## 2011 Change Proposals - New Allowances (4 Items) Posted by joepaluch - 27 Oct 2010 06:04

These are **PROPOSED** Changes only based on driver and director suggestions. Please comment below. These are prposed NEW allowances to the 944 spec rule set.

2011-3) Allow 924S models to use 924 Carrera GT type flares on the rear.

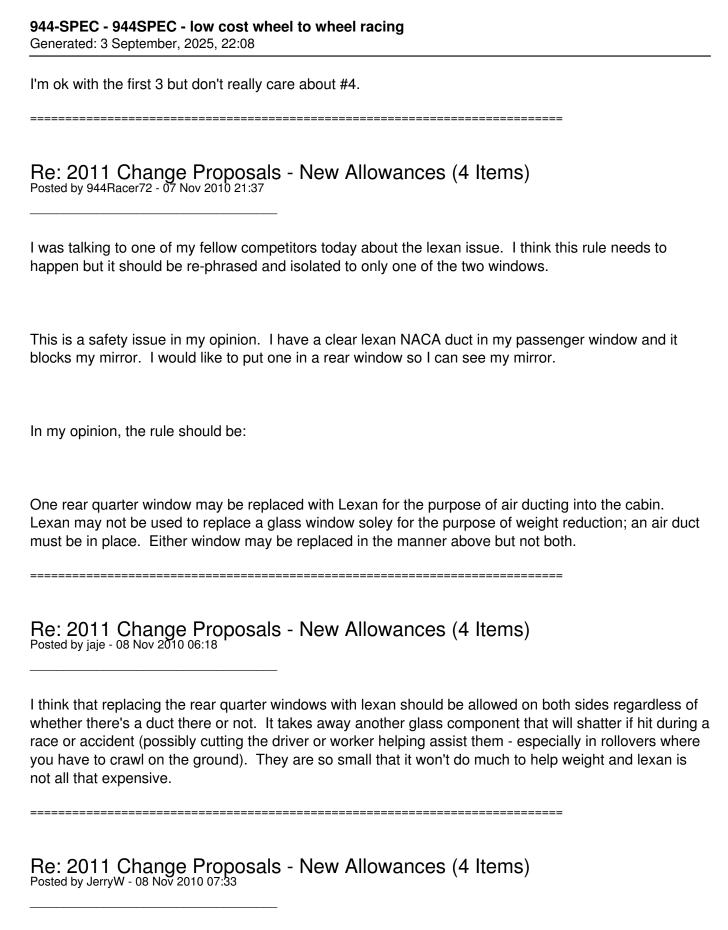
Proposal: All 87 and 924S chassis to install fiberglass 924 Carrera GT/ GTS type rear flares. Flares limited to units produce by GT racing part number xxxx (TBD). Track with may be increased the limit of the 944. If rear flares are installed the front must also convert to 944 steel fenders.

Justification: This allows a simple easy way for a narrow 924S to achieve the same track width as allowed by the 944. Front bodywork will be identical to the 944 and the rear flares are a cheaper solution than using 944 rear gtr panels.
